Outer Dowsing Offshore Wind

Response to Section 51 Advice

Schedule of Changes for Plans

Document Reference: 2.0

Drawing No: 22000087_PLN_INFO_13230.2

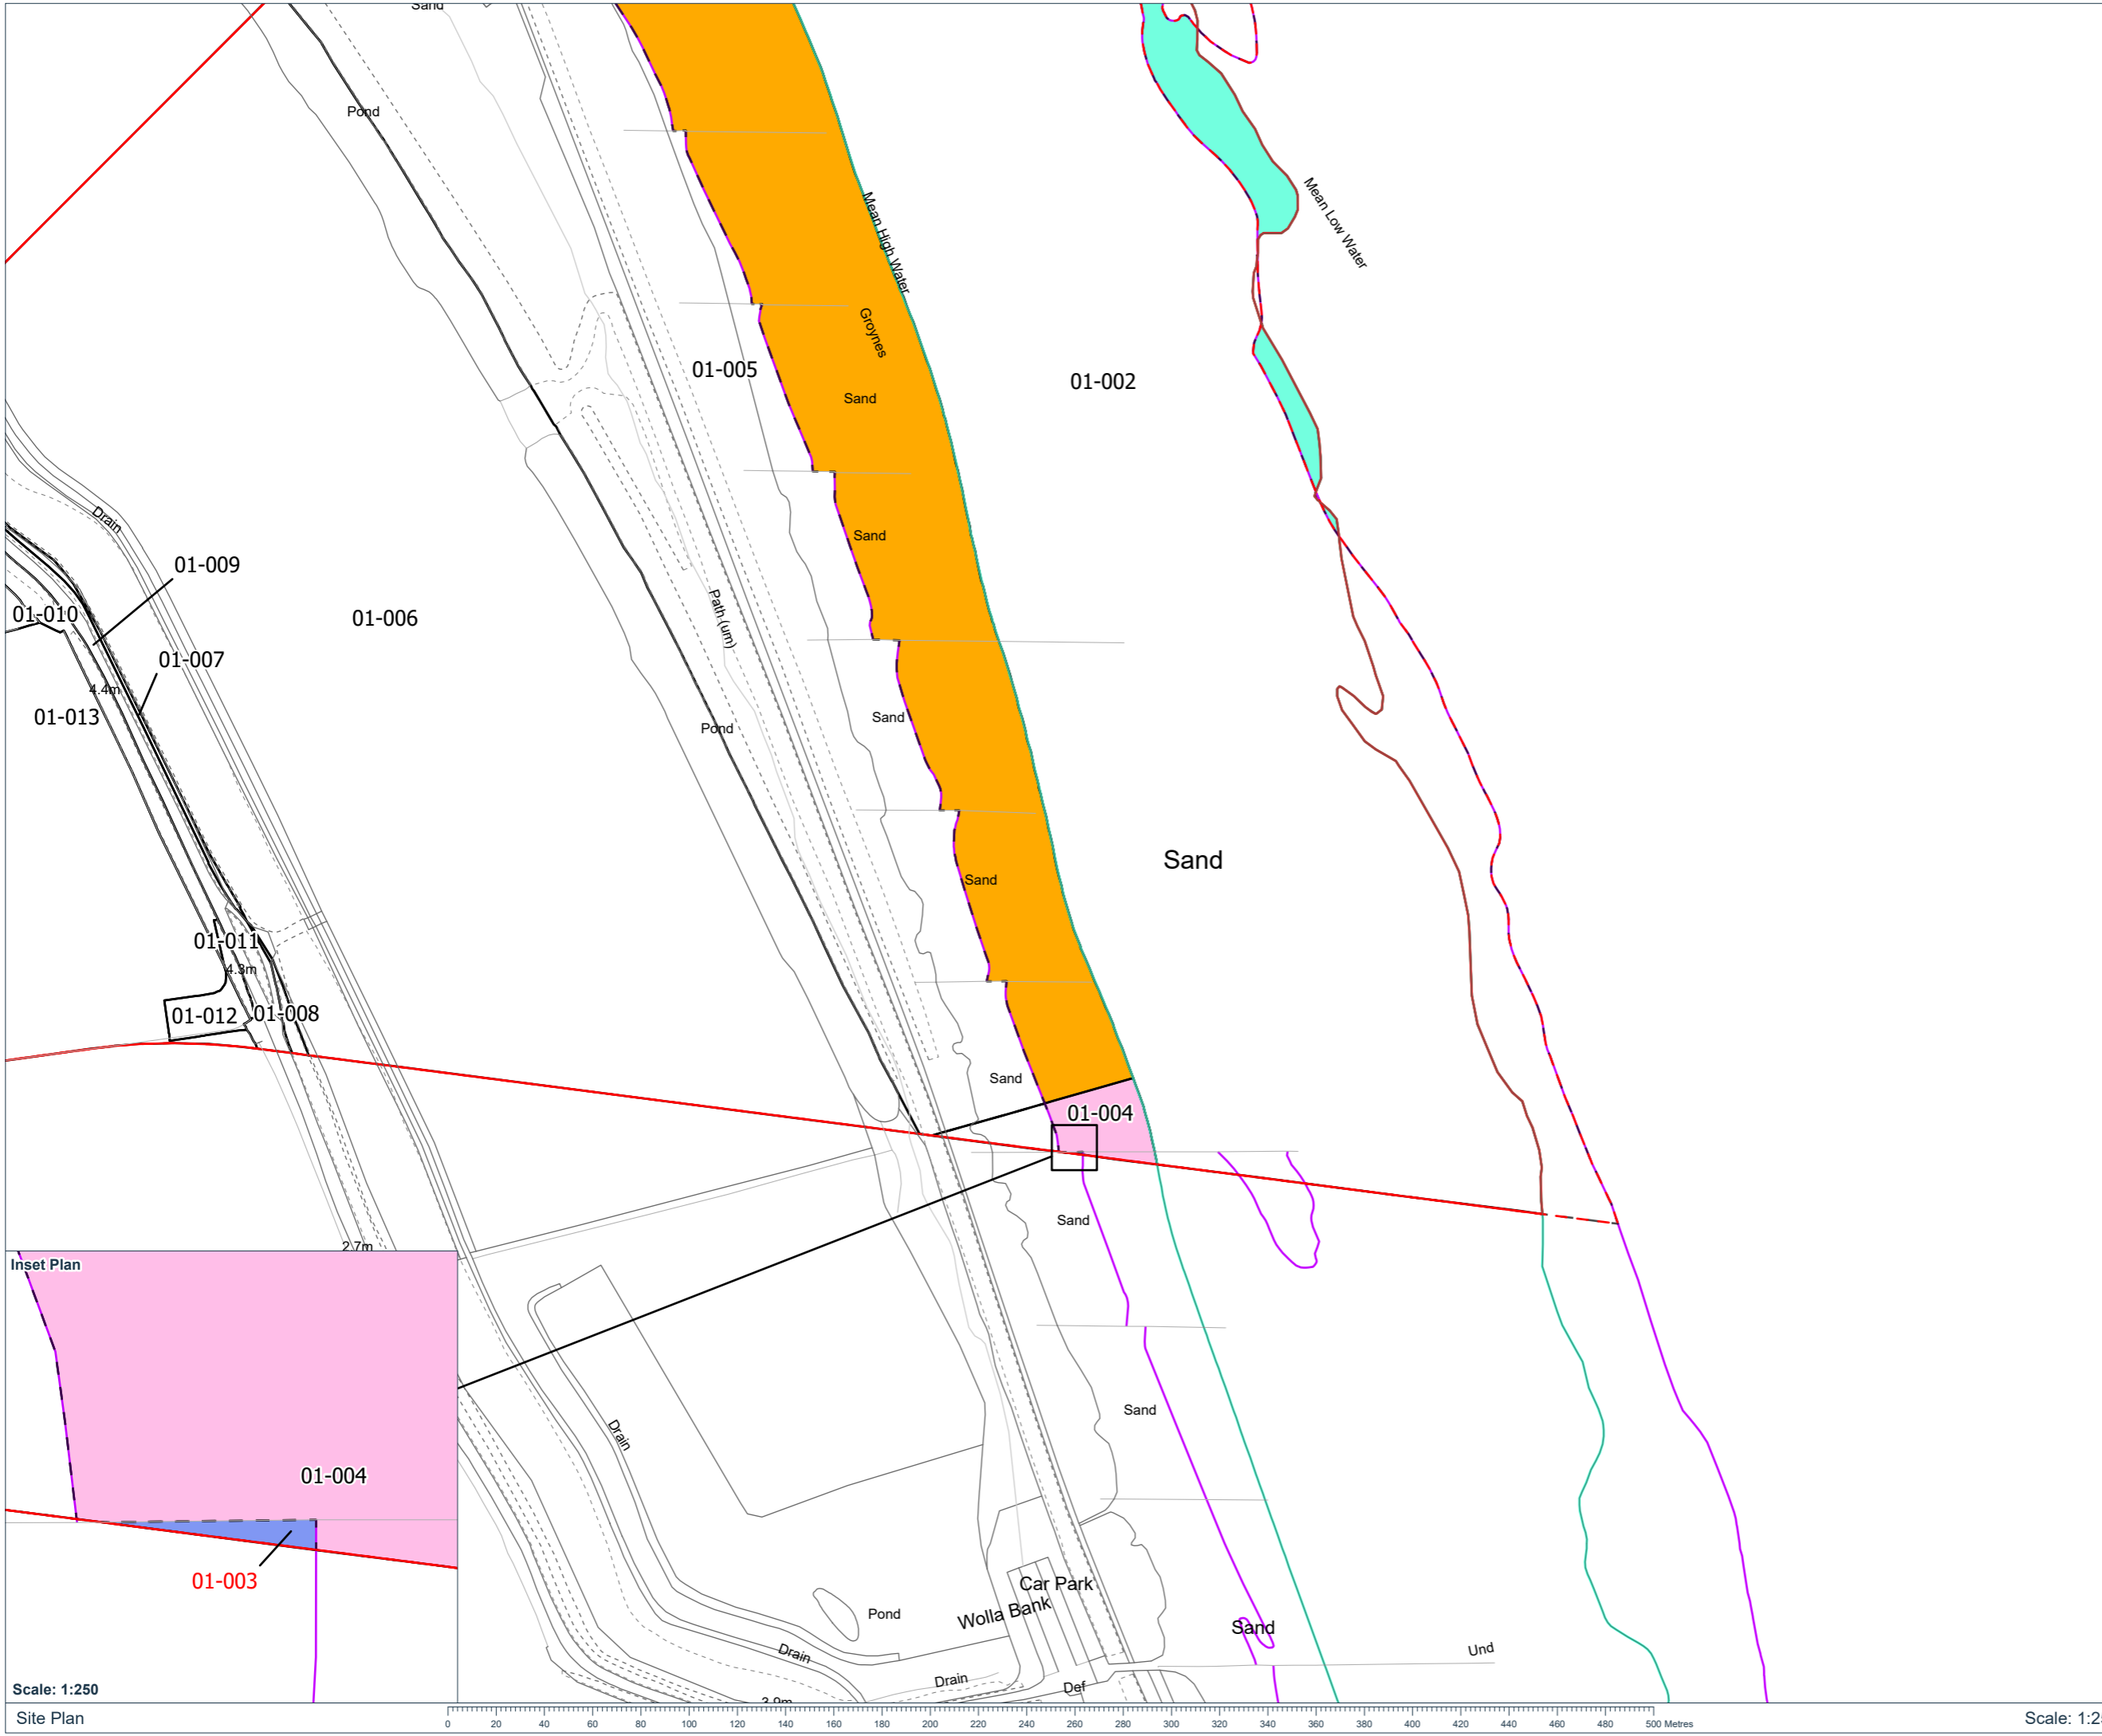
| Plan Reference Numbers | Plot Number(s) if appropriate | Date of Change | Revision Change | Change Made | Reasons for Change |
|------------------------|-------------------------------|----------------|-----------------|---|---|
| 2.5 | 01-001 | July 2024 | V2 | Order Limits re-shaped due to new mean high/low water mark updated. | Plot extent reduced following revised mean high/low water mark. Area reduced from 16239.96m ² to 11096.57m ² . |
| 2.5 | 01-002 | July 2024 | V2 | Plot reshaped due to new mean | Plot extent updated following revised mean high/low water marks. Area reduced from 146432.10m ² to 104733.20m ² . |

| Plan Numbers | Reference | Plot Number(s) if appropriate | Date of Change | Revision Change | Change Made | Reasons for Change |
|--------------|-----------|-------------------------------|----------------|-----------------|---|--|
| 2.5 | | 01-003 | July 2024 | V2 | Plot removed. | Due to changes to the OS data the extent and shape of land plots immediately adjacent to MLWS and MHWS has changed and plot 01-003 has been removed from the Order land. |
| 2.5 | | 01-004 | July 2024 | V2 | Plot reshaped due to new mean high/low water mark update. | Plot extent updated following revised mean high/low water marks. Plot area increased from 520.05m ² to 1635.17m ² . |
| 2.5 | | 01-005 | July 2024 | V2 | Plot reshaped due to new mean high/low water mark update. | Plot extent updated following revised mean high/low water marks. Plot area increased from 51048.88m ² to 83743.24m ² . |

- Key:**
- Order Limits (July 2024)
 - Order Limits (March 2024)
 - Land Plot
 - Previous Land Plot Extent
 - Land Removed from Order Limits
 - Land removed from plot 01-002 and added to 01-005
 - Land removed from plot 01-002 and added to 01-004
 - 2781.54m² of land added to plot 01-002
 - Current Mean High and Low Water Lines
 - Previous Mean High and Low Water Lines

Drawing No: 22000087_PLN_INFO_13230.3

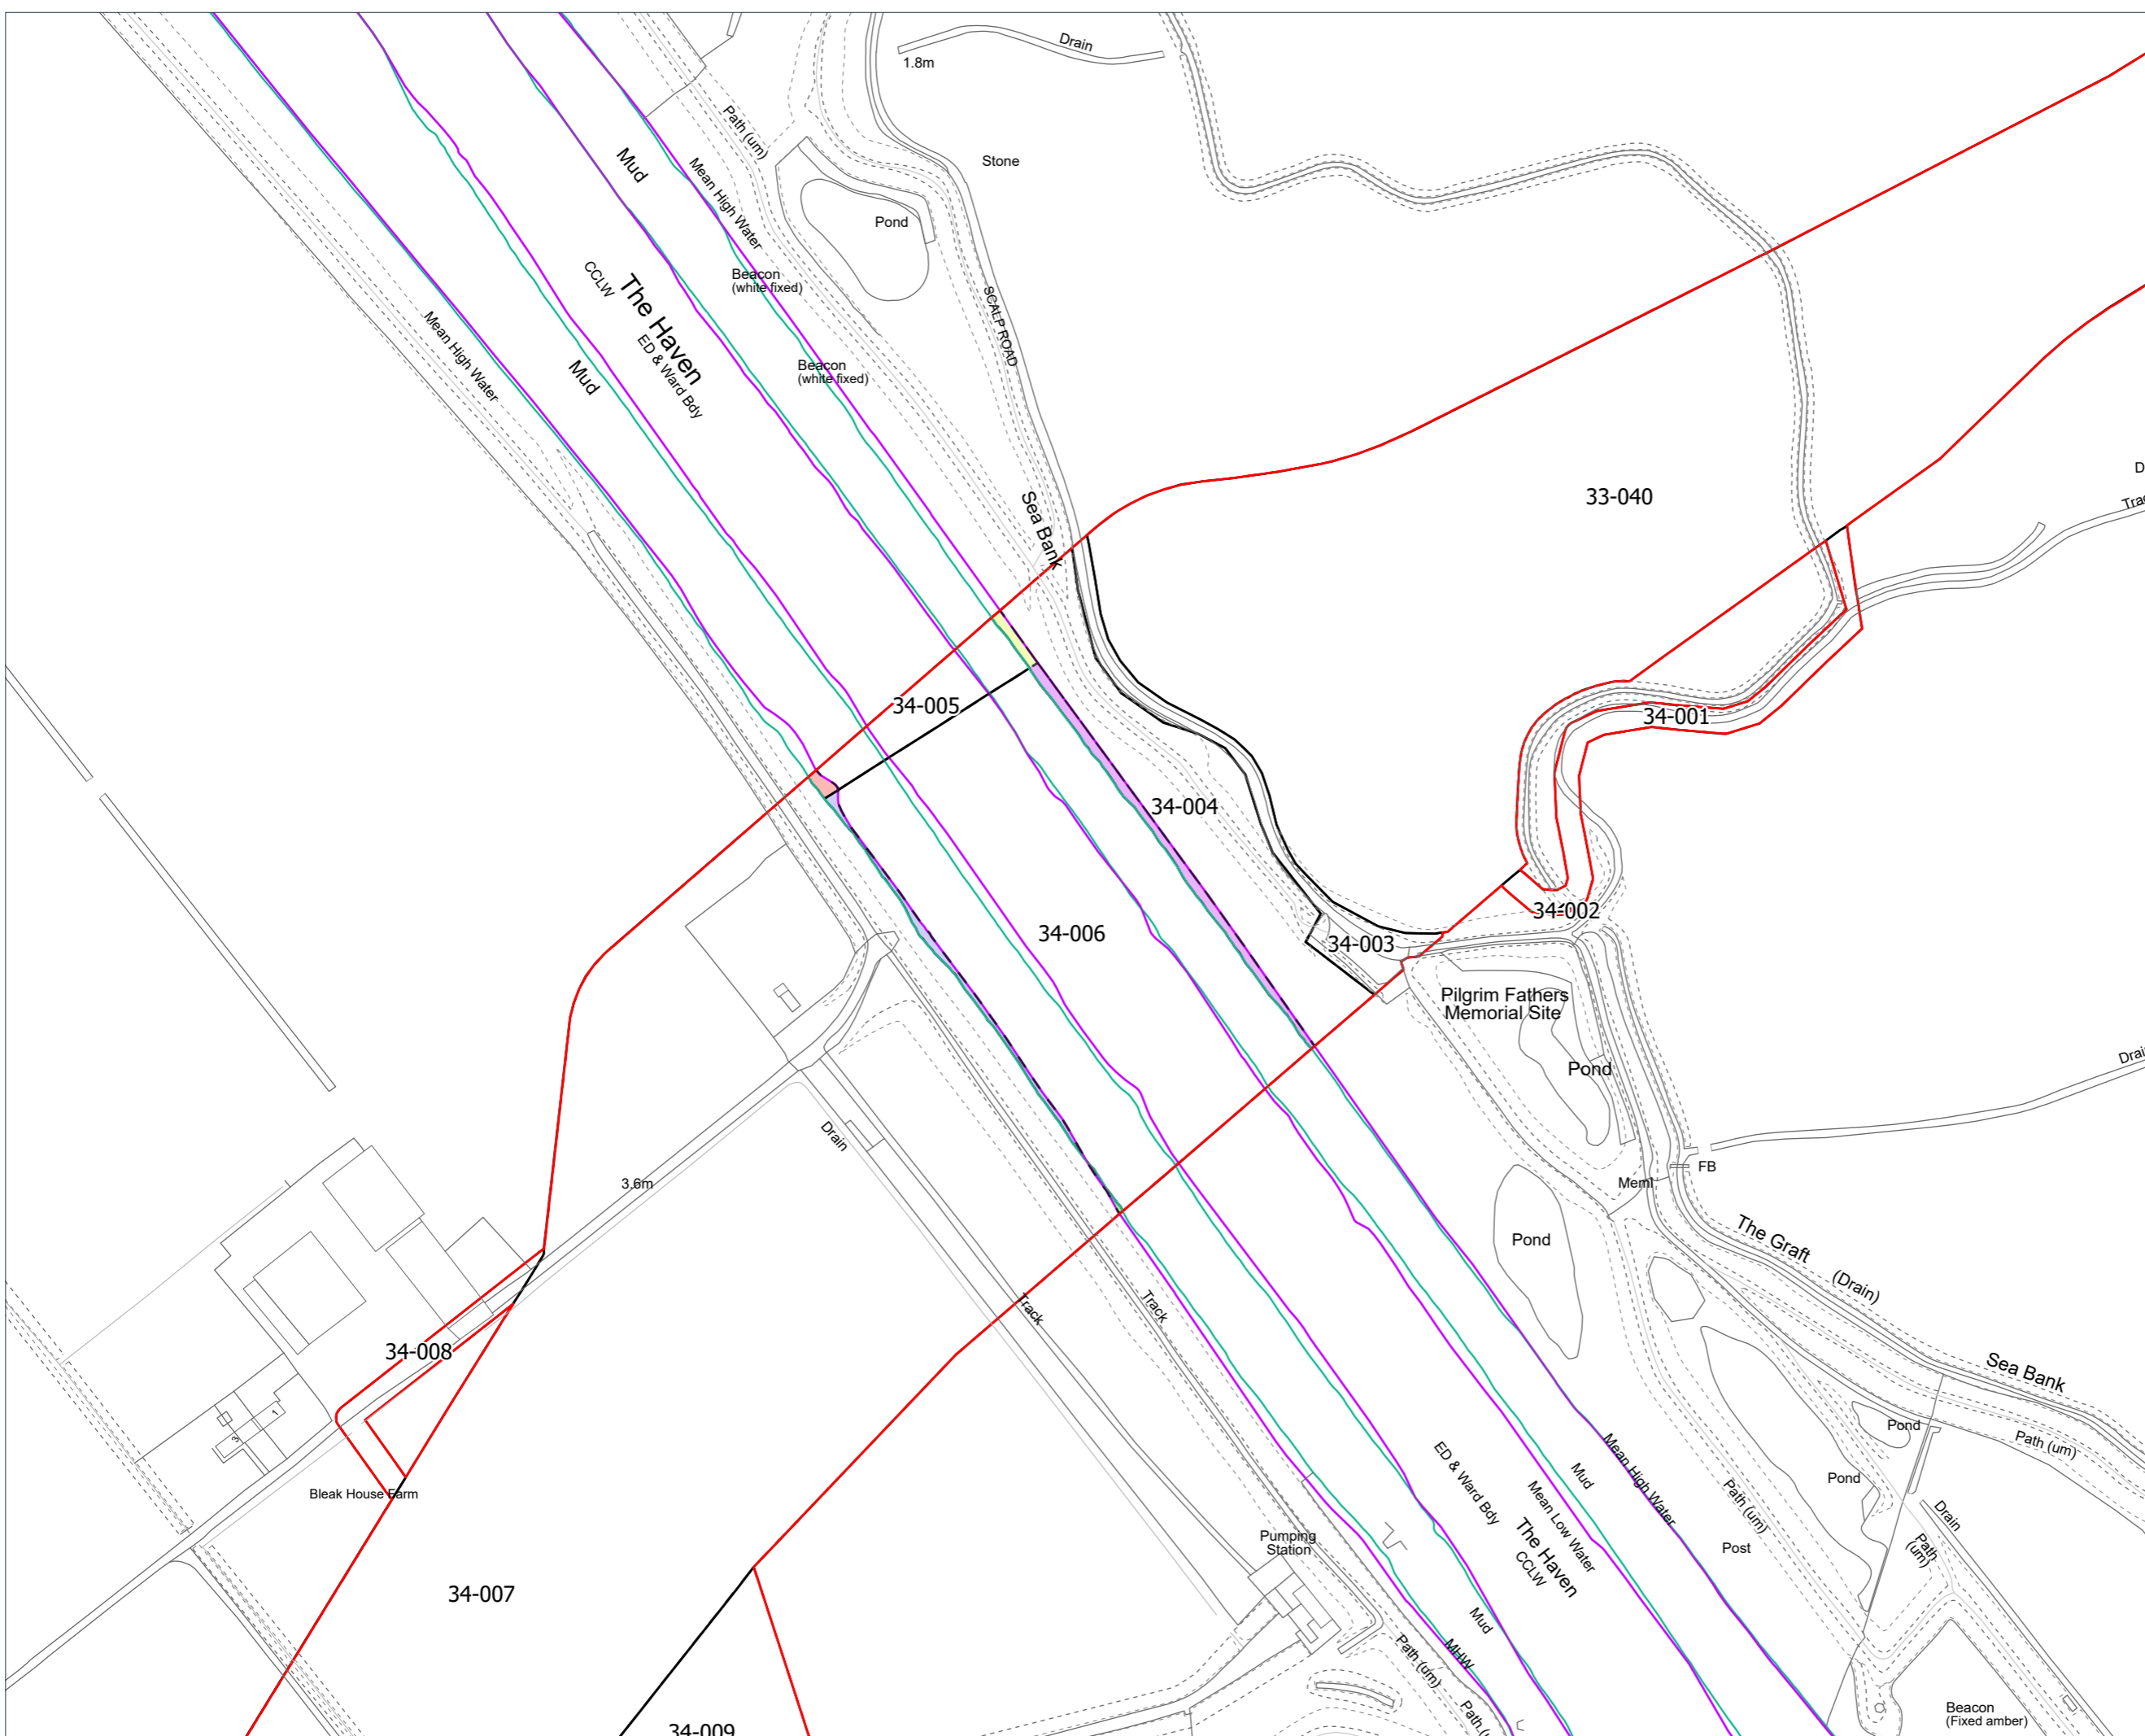
| Plan Numbers | Reference | Plot Number(s) if appropriate | Date of Change | Revision Change | Change Made | Reasons for Change |
|--------------|-----------|-------------------------------|----------------|-----------------|---|--|
| 2.5 | | 34-004 | July 2024 | V2 | Plot reshaped due to new mean high/low water mark update. | Plot extent updated following revised mean high/low water marks. Plot area increased from 6581.31m ² to 7341.42m ² . |
| 2.5 | | 34-005 | July 2024 | V2 | Plot reshaped due to new | Plot extent updated following revised mean high/low water marks. Plot area reduced from 1849.57m ² to 1808.34m ² . |

| Plan Numbers | Reference | Plot Number(s) if appropriate | Date of Change | Revision Change | Change Made | Reasons for Change |
|--------------|-----------|-------------------------------|----------------|-----------------|---|---|
| 2.5 | | 34-006 | July 2024 | V2 | Plot reshaped due to new mean high/low water mark update. | Plot extent updated following revised mean high/low water marks. Plot area reduced from 20132.73m ² to 19798.85m ² . |
| 2.5 | | 34-007 | July 2024 | V2 | Plot reshaped due to new mean high/low water mark update. | Plot extent updated following revised mean high/low water marks. Plot area reduced from 105198.16m ² to 104859.17m ² . |
